**Appendix 1      Stormwater evidence - WDC 3 Waters Manager**

**SUBJECT:** Evidence on Stormwater Servicing and Flood Risk Issues Relating to Private Plan Change P026 – Westpark, Lehmans Road, Rangiora

**Appendix 2    Wastewater Evidence - WDC Project Delivery Manager**

**SUBJECT:** Evidence on Wastewater Servicing Issues Relating to Private Plan Change PC026: Westpark Development, Rangiora

## **OUTLINE DEVELOPMENT PLAN**

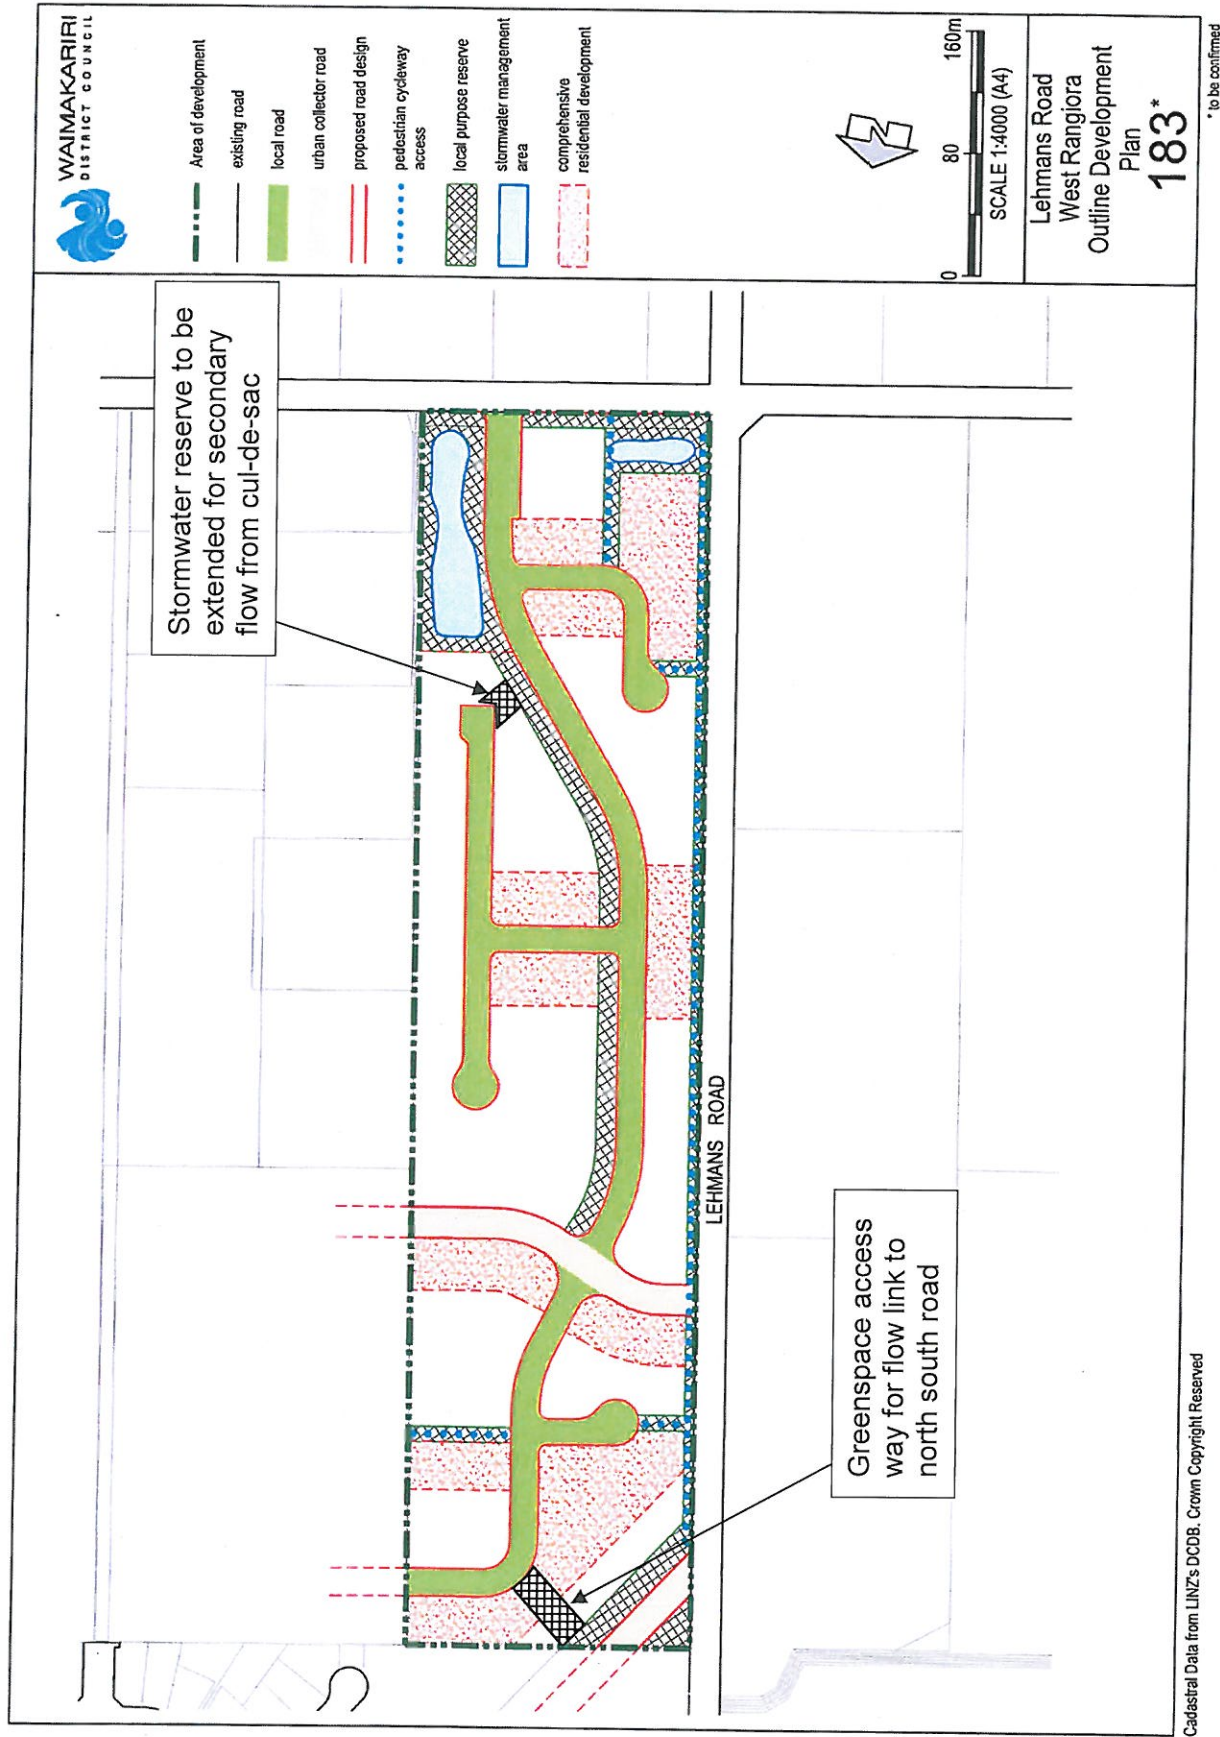
- i. Provision a flow link to intercept the flow path to the north of the site and direct it into the north south road (refer Attachment i). This could be provided in the form of a greenspace access way.

40. The layout of the roads on the Outline Development Plan are generally appropriate from a drainage perspective, however the southern cul-de-sac to the east of the north-south local road has no provision for secondary flow (refer Attachment i).
41. The indicative stormwater system shown on the plan in Appendix B of the Infrastructure Report shows a proposed stormwater reserve for the piped system and secondary flow. However, this has not been included in the proposed Outline Development Plan.
42. ODP Layout Summary
43. From my evidence, I offer the following summarising statements:
- (a) The Applicant has not appropriately provided for secondary flow in the layout of the proposed Outline Development Plan.

- ii. Secondly, amend the proposed Outline Development Plan to include:
    - (a) A greenspace access way to the north of the development to provide a flow link to the north south road for flood flow management.

- (b) A stormwater reserve connection from the southern cul-de-sac to the east of the north-south local road to make provision for stormwater infrastructure and secondary flow.
